Comment Date: January 26, 2012 23:56:11PM
Supplement to the Draft Solar PEIS
Comment ID: SEDDSupp20100

Re: Joint Comments on Supplemental Draft PEIS for Solar Development

Figure 3: Probability of Tortoise Occurrence near Soda Mountain Solar Project Area

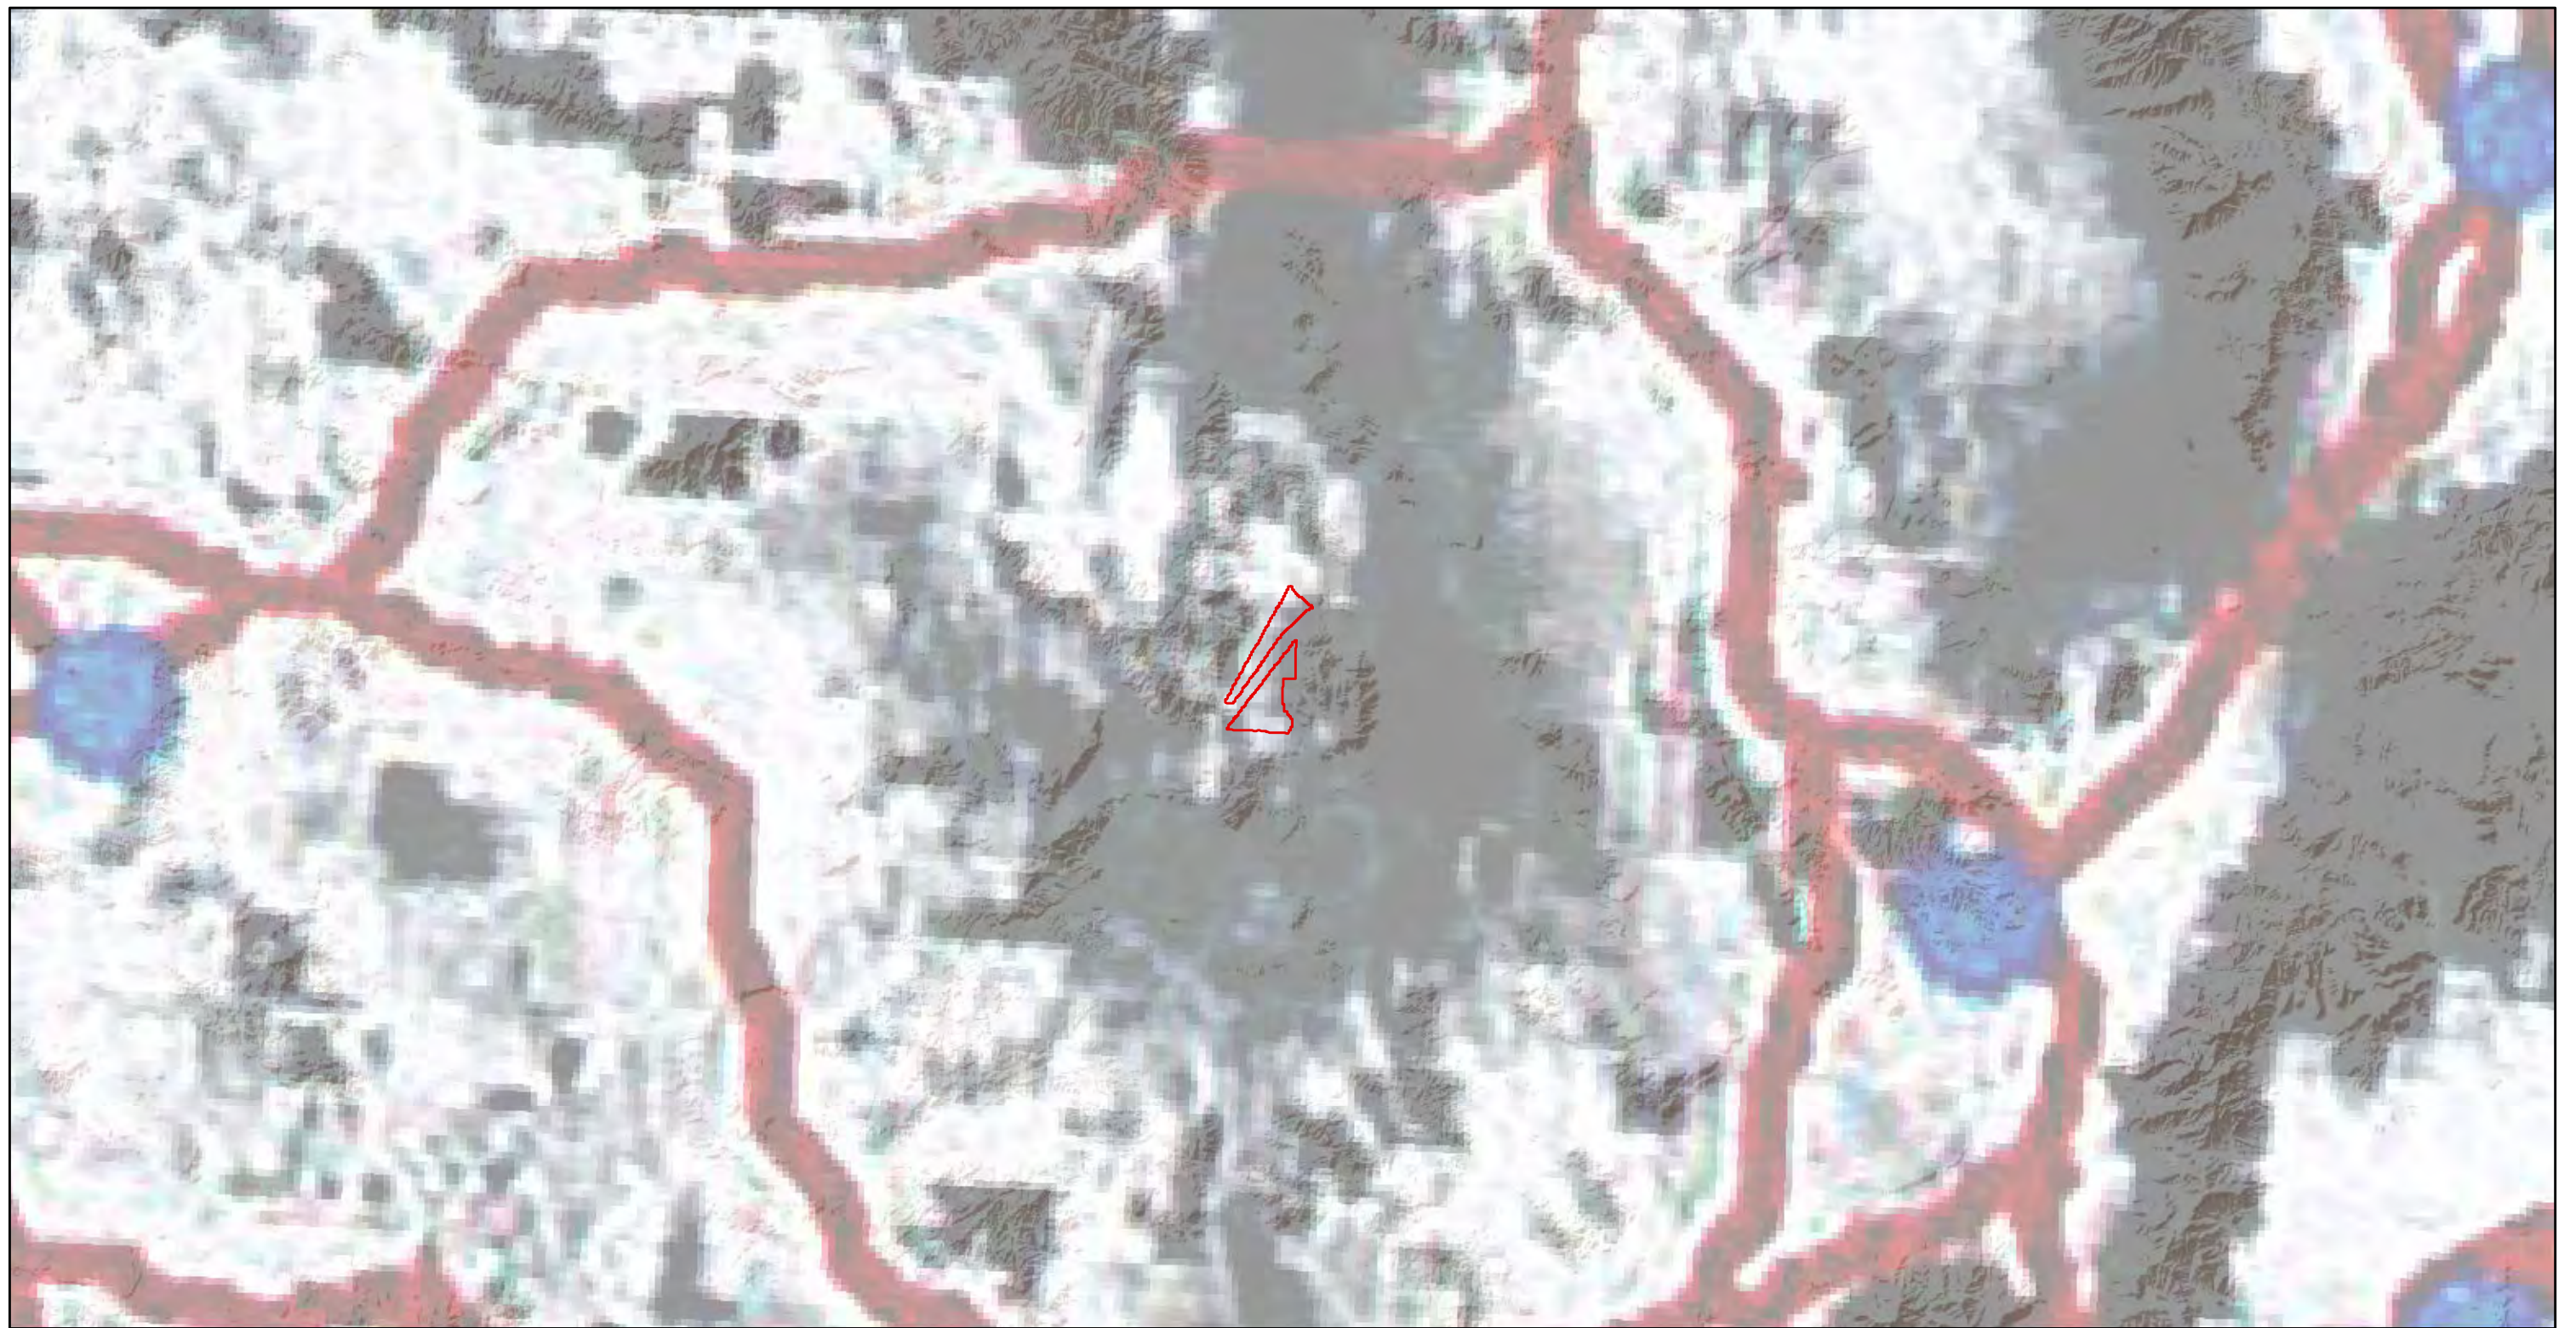
A recent National Park Service article (Hagerty and Tracy 2011) corroborates this conclusion with a genetic study determining that the Soda Mountains and Baker Sink serve as effective barriers to desert tortoise migration and indicating that the area around the Soda Mountain Solar Project site has a low probability of tortoise occurrence, with likely connectivity pathways located well north, east, south and west of the Soda Mountain Solar Project site (Figure 3).

The SDPEIS includes a map depicting "Desert Tortoise Conservation Areas and Proposed Connectivity Areas." (SDPEIS Figure 2.3-1, page 2-44). We request that the proposed connectivity area overlaying the Soda Mountain Solar Project in the valley between the Soda Mountains south of Baker, west of the Mojave National Preserve (MNP), be removed for the following reasons:

Figure 6. Amargosa Valley SEZ

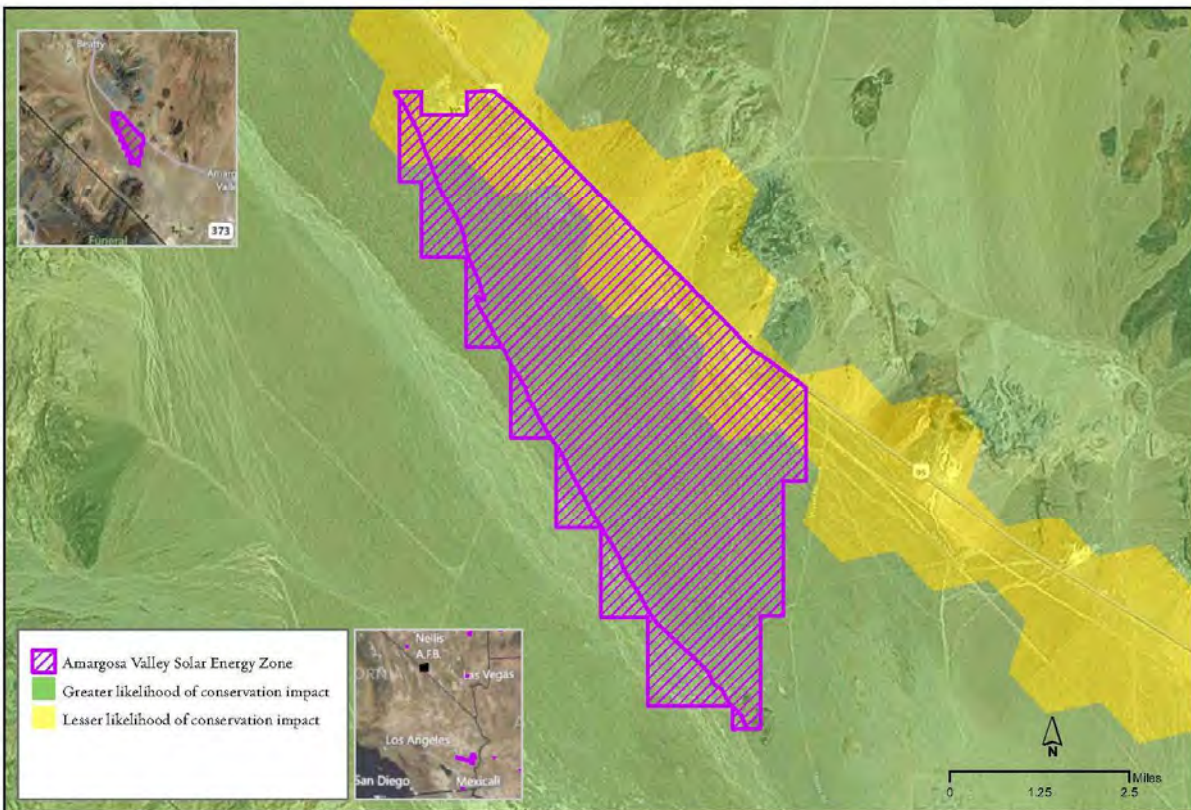
This valley (Figure 6) is already scheduled to be heavily compromised by ongoing existing renewable energy applications, two of which are on the "fast track" course. There has been no explanation why additional facilities are needed in this general area given the scale of the existing proposed facilities. According to the Nature Conservancy's 2010 Ecoregional Assessment for the Mojave Desert, the majority of this SEZ is contained within Ecologically Core zone with an additional 1,278 acres of Ecologically Intact lands. Only one quarter of this SEZ is within Moderately Degraded category, and that principally located along US Highway 95.

Figure 7. Big Dune in Amargosa Valley with Likely Sand Transport Pathways

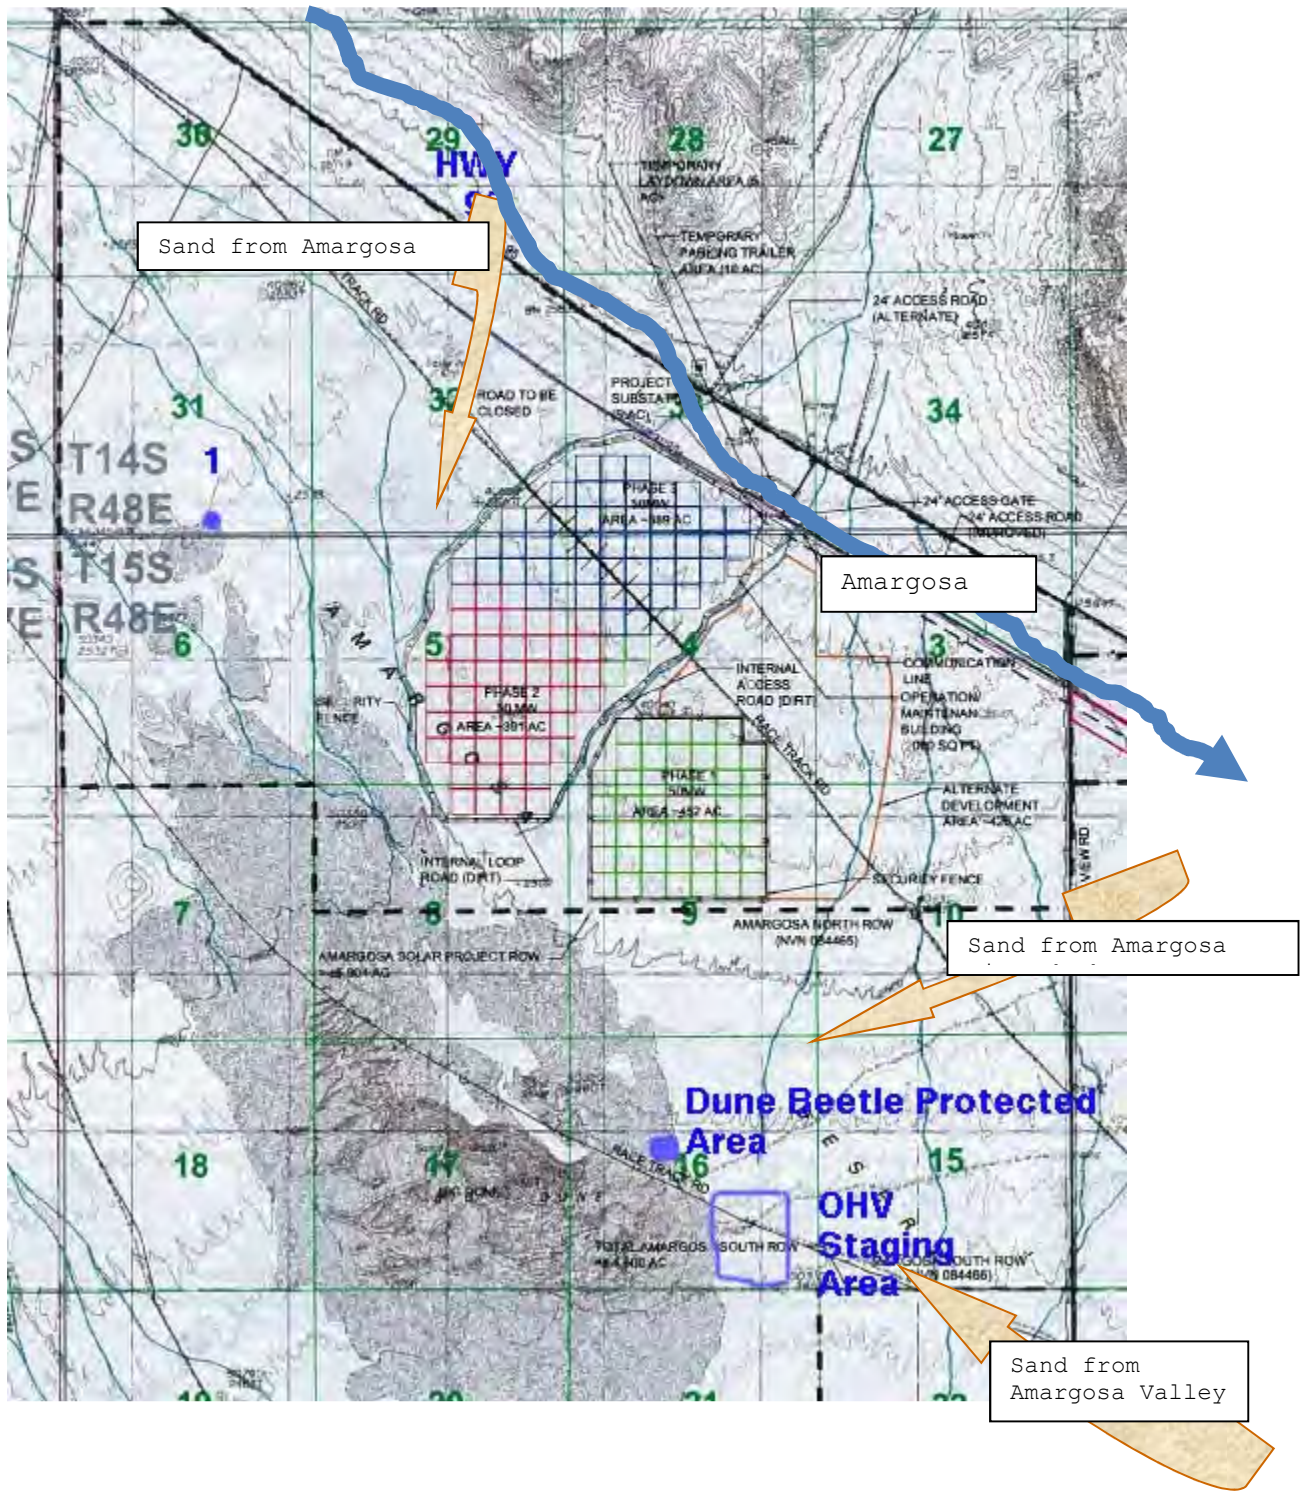
Additionally, the presence of Big Dune at the core of the Amargosa Valley should cause serious concerns that the proliferation of renewable energy facilities will interrupt important sand transport pathways from the Amargosa River bed and nearby dry lake beds to the south and east of this valley (Figure 7).

Figure 8. Dry Lake SEZ

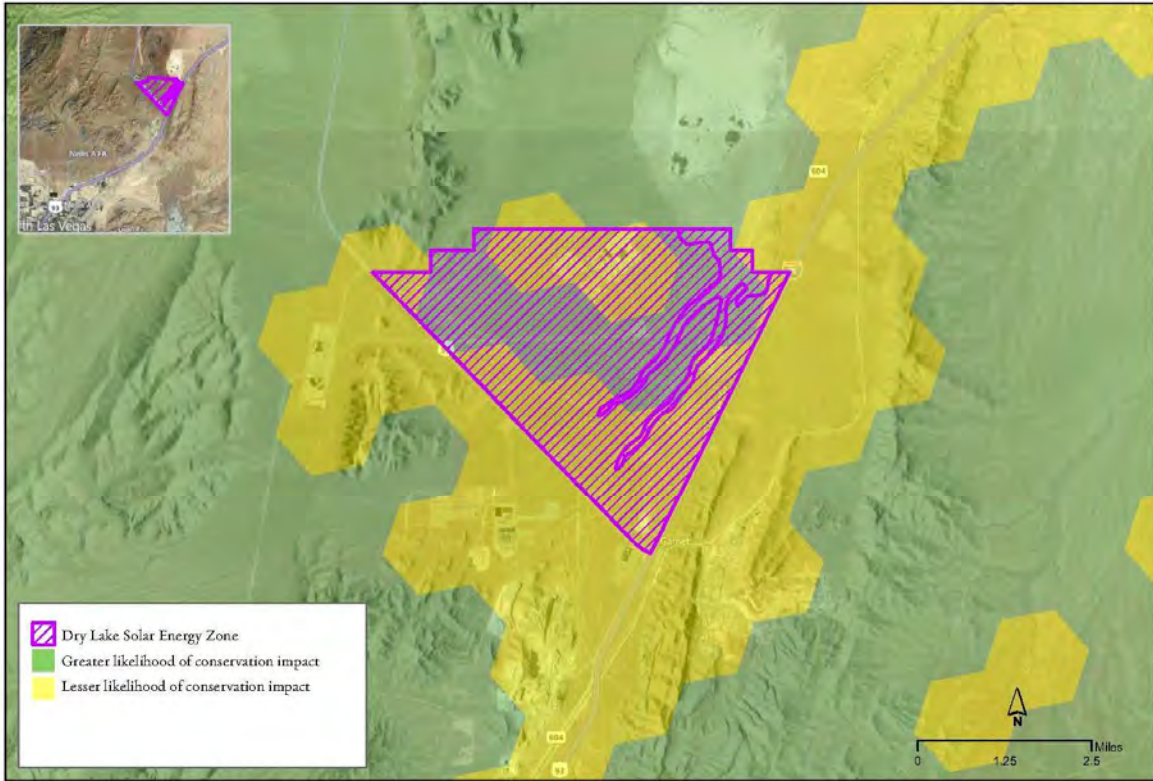
This location is generally suitable and appropriate with the exception of the washes leading to the playa wetland at the northern end of the SEZ. This area should be eliminated from the SEZ and the acreage could be replaced with that to the east and south of the Dry Lake on either side of Interstate Highway 15.

Figure 9. Gold Point SEZ

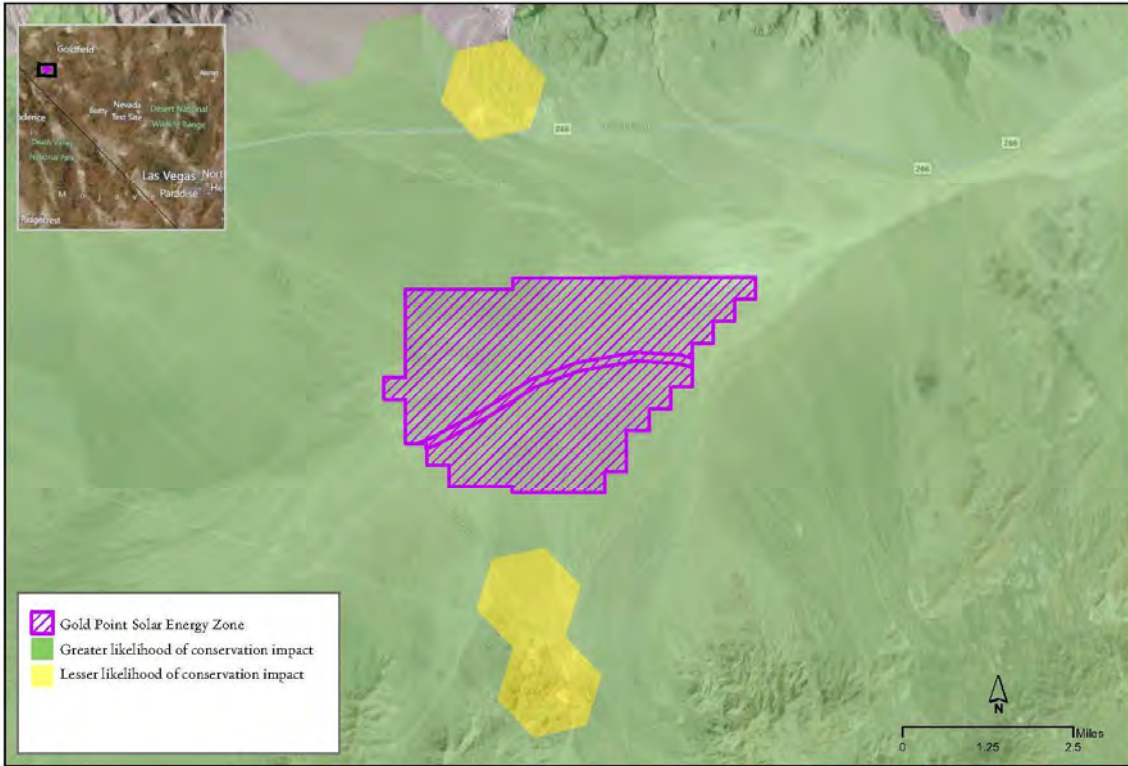
This SEZ is remote and not regionally significant as far as demonstrated power needs and furthermore is currently ecologically intact. It should be removed from consideration or relocated to nearby degraded or converted lands. Moving the SEZ could also alleviate transmission corridor concerns since the new corridor could parallel US 95 without appreciable additional impacts to the Pronghorn antelope and Greater Sage Grouse.

Figure 11. Riverside East SEZ

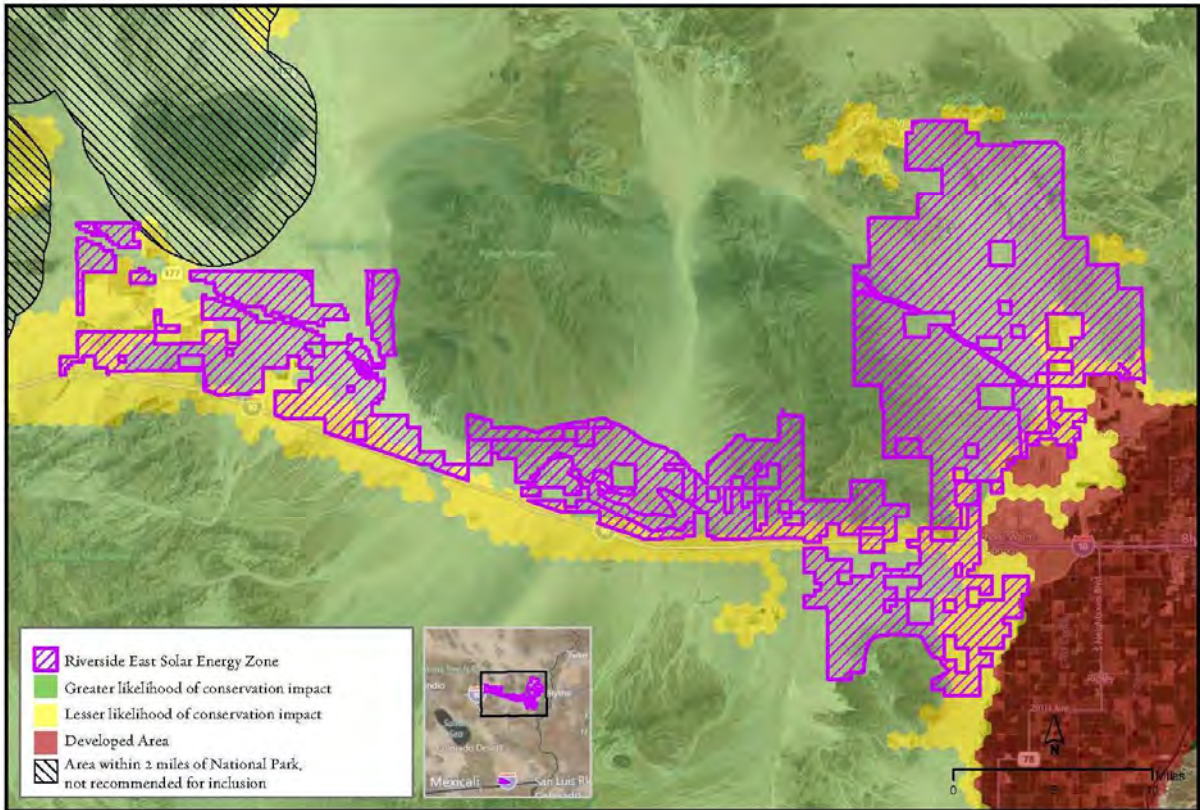
The Riverside East SEZ is divided between Moderately Degraded, Ecologically Intact and Ecologically Core lands. Over 31% of the Riverside East SEZ is comprised of lands identified as having high conservation value in the 2009 Framework for Effective Conservation Management of the Sonoran Desert in California because they are un-fragmented and host important species and communities. We recommend the withdrawal from this SEZ of the highest conservation value lands shown on the accompanying map. Areas that should be withdrawn from this SEZ include lands around Palen Dry Lake in the northwestern portion of the SEZ, and the high value habitat northwest of Blythe. In addition, the large size and long, thin shape of this SEZ may hinder the north-south movement of Bighorn Sheep and other wide-ranging terrestrial vertebrate species. The shape of the SEZ should be modified to incorporate viable wildlife linkages and provide connectivity for hydrological and ecological processes such as sand movement in this region.
